For details see LK0142-1-1

geoend. changed	20/11/2019	TOR	C0121072	Device added for support the connector. Minor changes for cost saving	Change-description
	Datum Erstellt/ Drawn	Date Datum Date	Name Name Name	TAE-Nr. Name Name	Aenderungsbeschreibung Scale

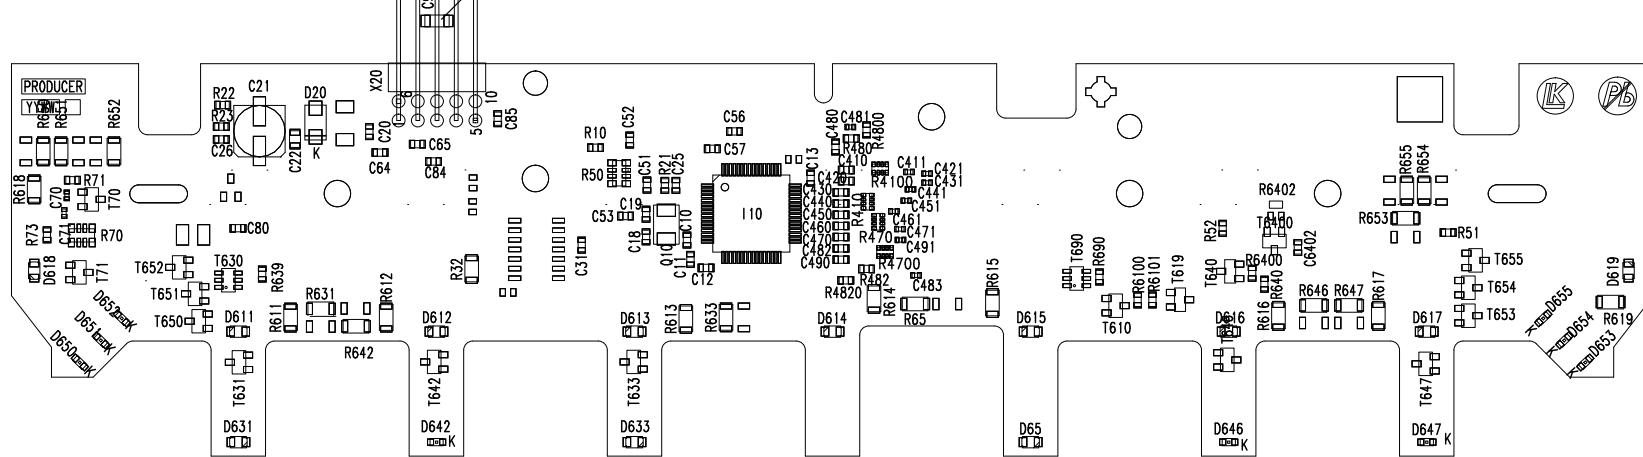
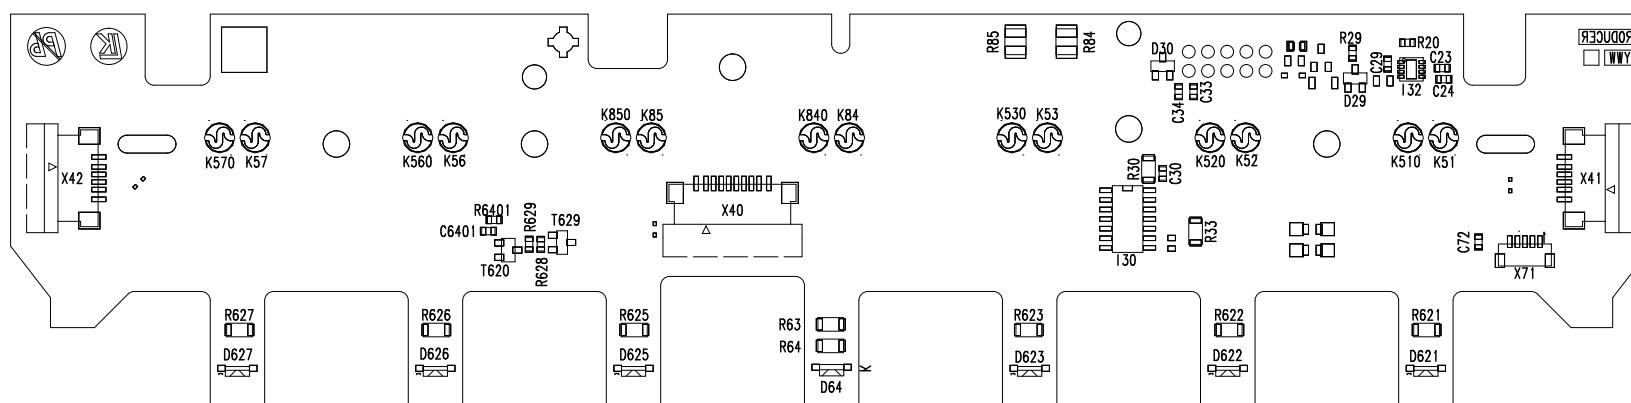
Capacitor C99 is assembled on the waste part of the panel, outside the PCB. Its aim is that the horizontal pins of the connector lean on it during the electronic assembly process, so the connector keeps its right position. After the de-paneling process, C99 is not to be found on the circuit.
